ADDENDUM NO.: 4

PROJECT NAME: **POLICE TRAINING ACADEMY HVAC COMPONENT REPLACEMENT**

DATE: 7/15/2013

CIMS PROJECT NO.: **35-06010**

SHEET
MD1.1
OF:

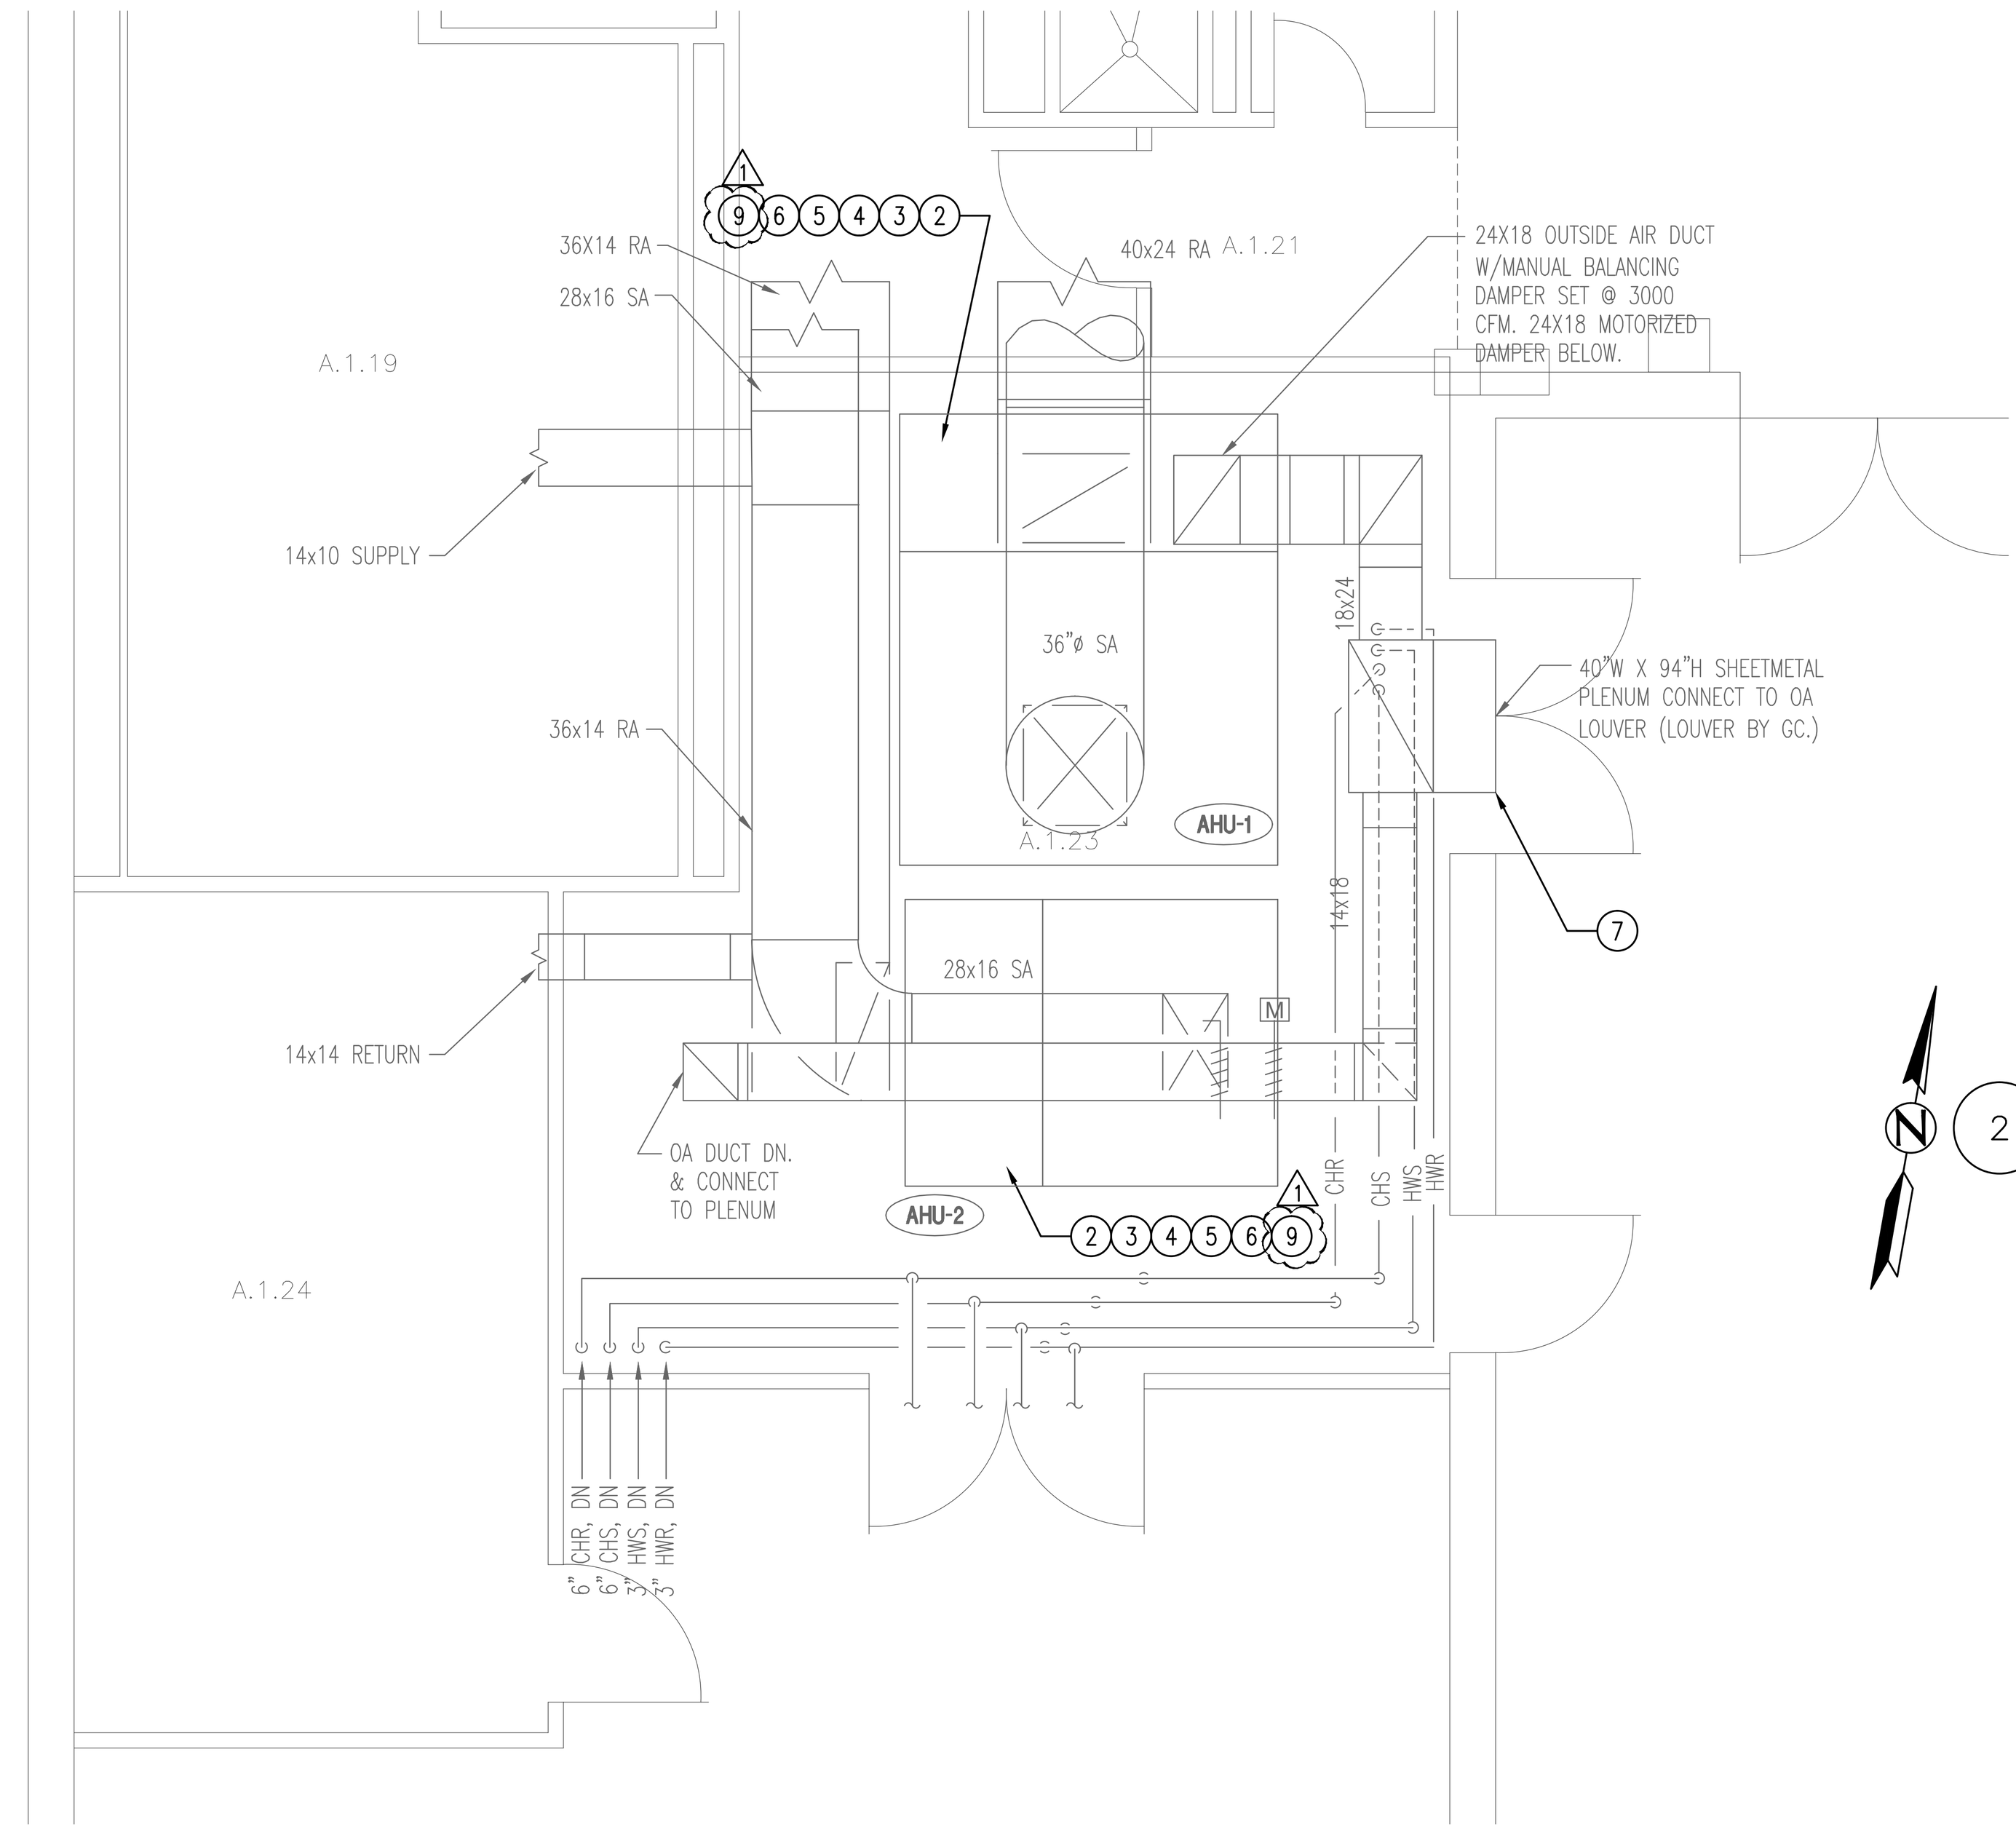
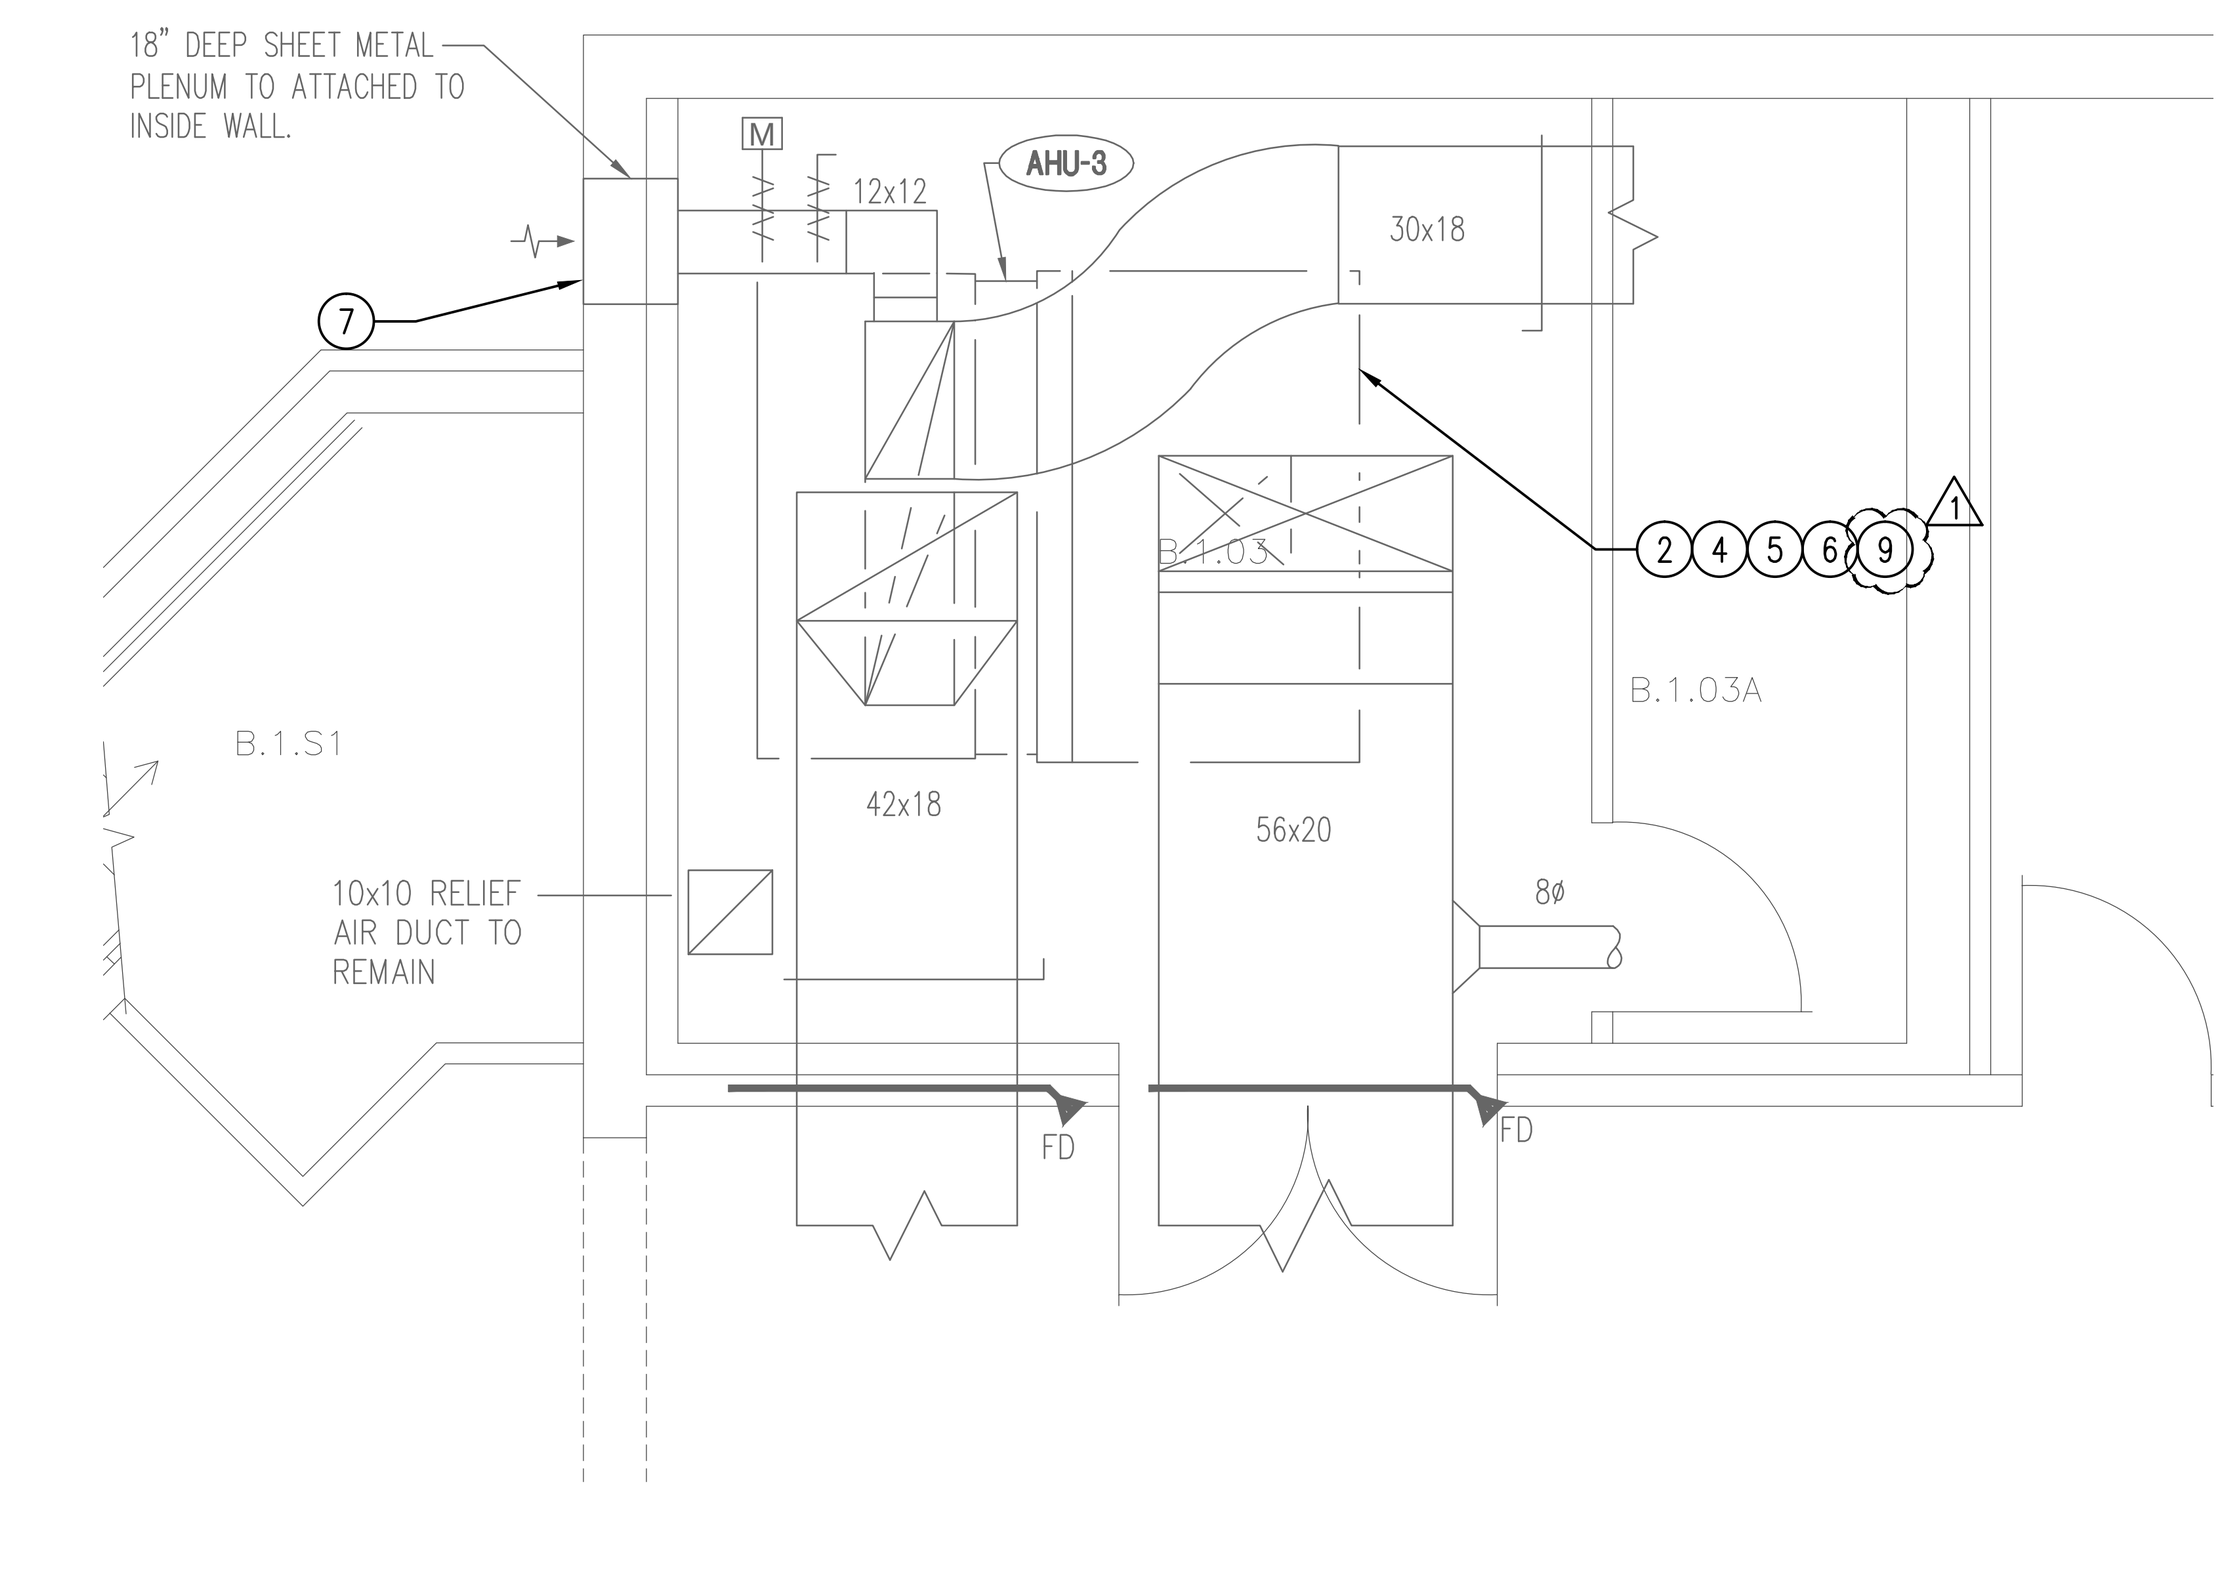
PLAN SHEET MD1.1

- Existing air handling units are to remain. Their respective coils, fan motors, condensate drain pans and piping and internal casing insulation is to be replaced with new.
